Keck Adaptive Optics Note #366

**Development Team Response to the NGWFC Preliminary
Design Review Committee Report**

October 27, 2005

Timeline as Presented at PDR

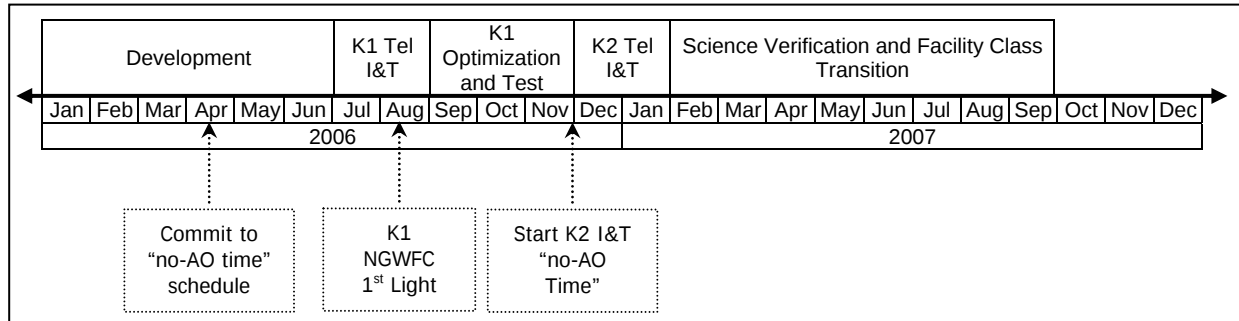
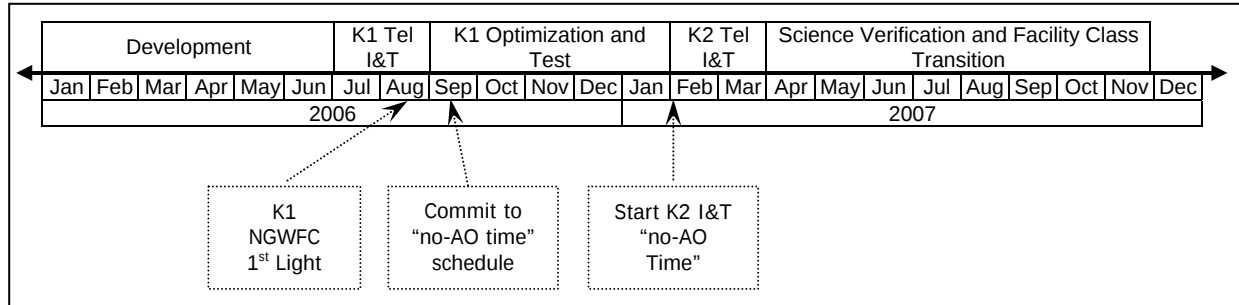
The committee considers both the K1 and K2 I&T schedule to be very risky. The time between first actuator motion on K1 and resumption of science using K1 appears

insufficient. Premature resumption of K1 AO operations carries the risk of not understanding a key issue, then suffering the same problem on K2. The total allocation of "no-AO time" for K2 is likely also insufficient, based on our experience upgrading AO systems, with which we have also been very familiar. The panel strongly recommends that the Observatory consider allocating longer AO downtime for both K1 and K2. CARA should explore a strategy of greater upfront allocation, combined with a return of engineering time to science operation, upon successful I&T on both K1, then on K2.

There are several approaches being considered. One point raised is that the current NGWFC schedule has us doing K2 I&T at the very end of semester '06B. (December '06 and January '07) which would require us to make the decision to commit to a schedule for the "no-AO time" in February or March of '06. If, however, we scheduled K2 I&T for the beginning of semester '07A (February and March of '07) then we would not have to commit to the "no-AO time" schedule until August or September '06. So, basically delaying K2 I&T by two months would allow us to get an additional 6 months of system development behind us before we had to make the final decision on scheduling "no-AO time" for K2. This should reduce the risks since we would be making decisions based on better information, and also the extra 2 months before K2 I&T could be used

to further reduce risk by allowing us more time for lab and K1 sky testing. The timelines associated with these two options are shown graphically in the figures below.

These options, as well as others, are being considered. We will have a recommendation by DDR.

Figure 3 – Tip-tilt power spectrum on Keck II. The frame rate was 660 Hz and the tip-tilt gain was 0.5. The modeled power spectrum assumes tip-tilt mirror dynamics.

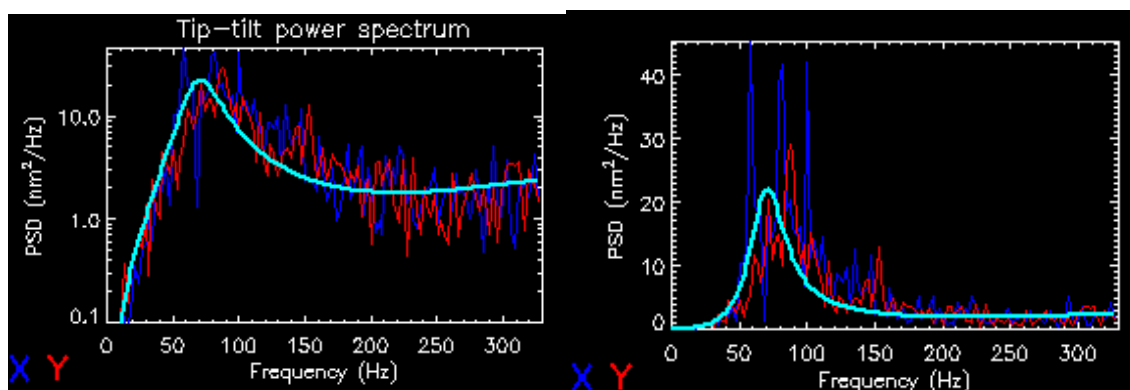
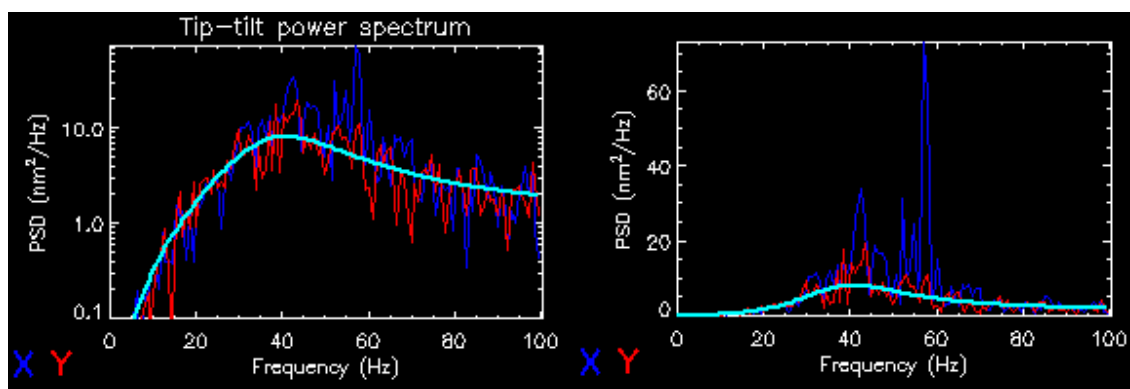
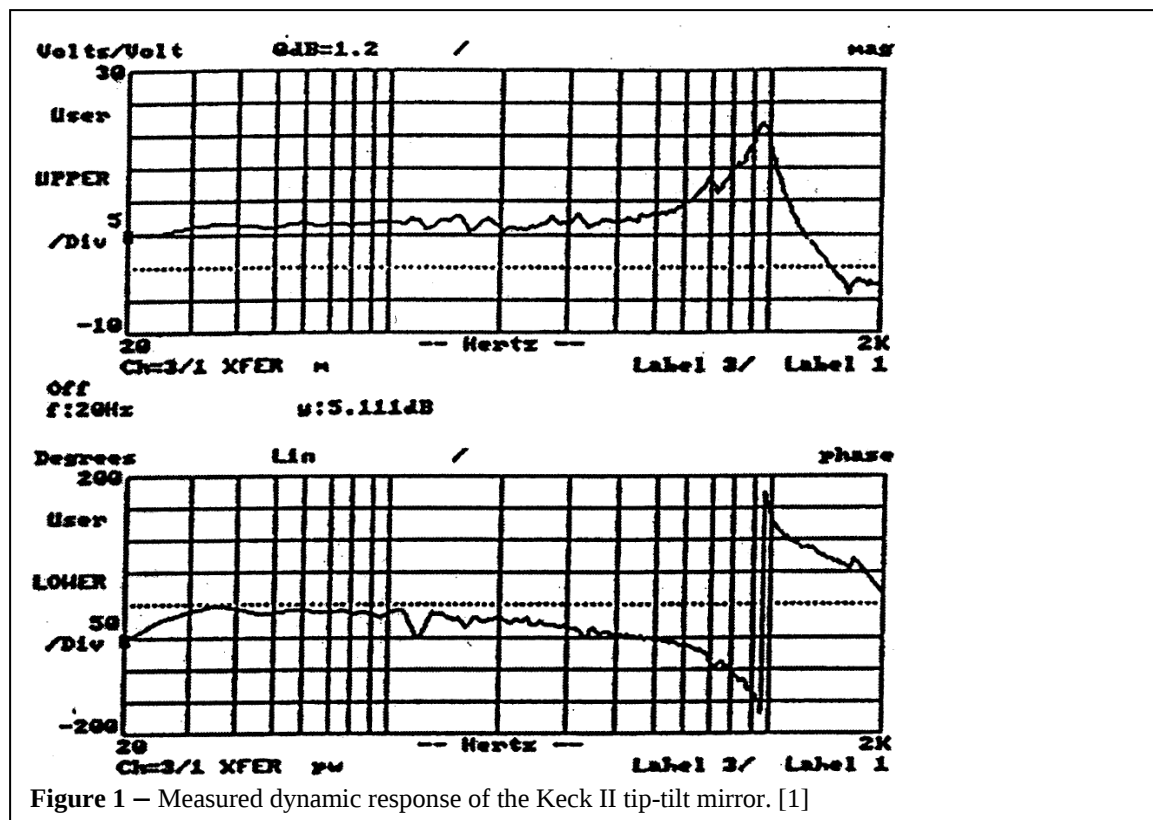
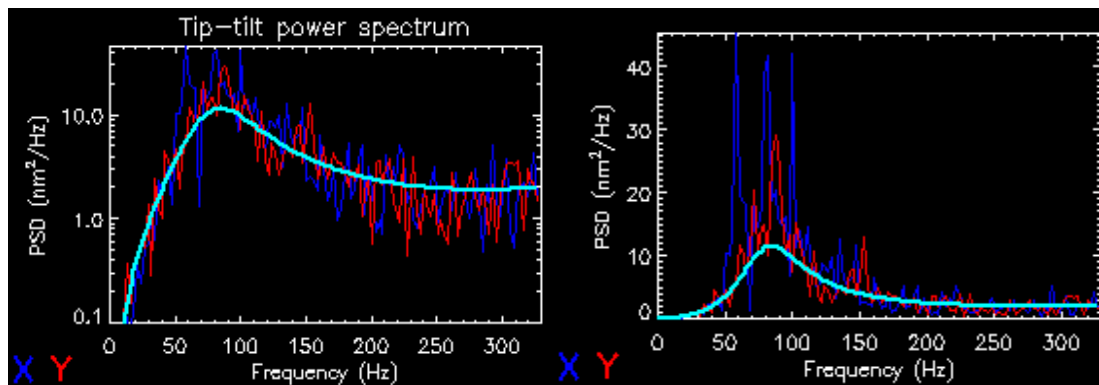
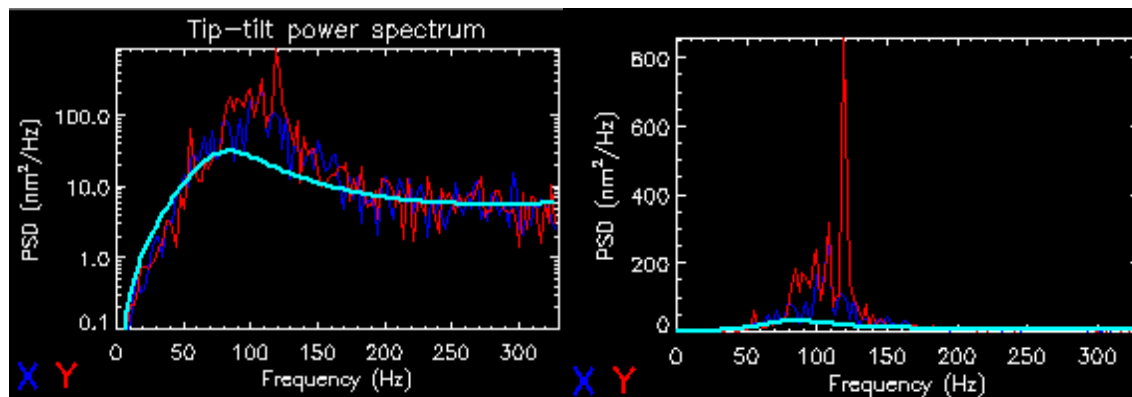
The committee feels that use of the UTT strain gauge feedback is not currently supported by scientific gain and recommend management review its necessity/desirability.

The issue of driving the DM and tip tilt mirror at rates higher than in the current system has not been addressed. This is separate from the design decision to include strain gauge feedback in the tip tilt controller. This may be outside the scope of NGWFC, but appears to us a 'hole' in the plan for improved science with NGWFC.

DTT: Subsequent to the review, we revisited the issue of strain gauge feedback in the DTT controller and determined that it is indeed required for optimum tip-tilt system performance and for preventing uncontrolled oscillations in the tip-tilt mirror. This is documented in **KAON 355: Characterization of the tip-tilt mirror**. After considering both the cost issues and the performance benefits, we have decided to retain our current design approach, which is to implement and use the strain gauge feedback in the DTT controller.

Tip-tilt mirror: The tip-tilt mirror has mechanical resonances at approximately 700 Hz and 1 kHz which are easily excited, even with our current system (see section 6.2 above and KAON 355). At loop rates higher than our current system maximums (672 Hz WFC, 1 kHz STRAP), exciting these modes will become even more problematic. We believe driving the tip-tilt mirror at these higher rates cannot be separated from the strain gauge feedback issue. Strain gauge feedback is required to properly tune the controller to dampen the response at the resonant frequencies. Furthermore, driving the mirror at high rates without the strain gauge feedback will most likely

lead to mirror instabilities and oscillations which can only be mitigated by turning down the controller gain, resulting in poor tip-tilt performance and lower Strehl. Our conclusion is that strain gauge feedback is required in the DTT controller in order to drive the tip-tilt mirror at rates above our current maximums.

Figure 1: Location of subapertures in the CCD

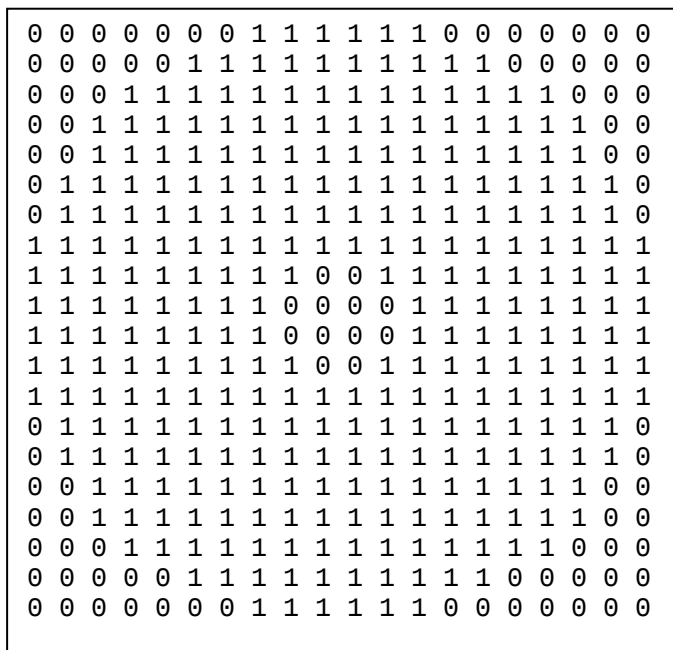
We recommend retaining the center subapertures in the controller calculation for purposes of alignment.

Since the PDR, we have investigated this option (see **KAON 358: Reading the subapertures behind the central obscuration**), and have concluded that the benefits are not enough to warrant a change order for to the RTC. We can however still implement this feature using the WFS raw frames in the telemetry stream and processing in IDL if needed.

If the AO system was designed from scratch, the centrally obscured subapertures should probably be retained. However, the amount of work needed to retrofit this into the existing code is not warranted. A partial solution, which will improve the wavefront sensor calibration, is to close the DM loop in IDL by deriving the centroids in IDL from pixel data in the telemetry. This could be implemented later if necessary.
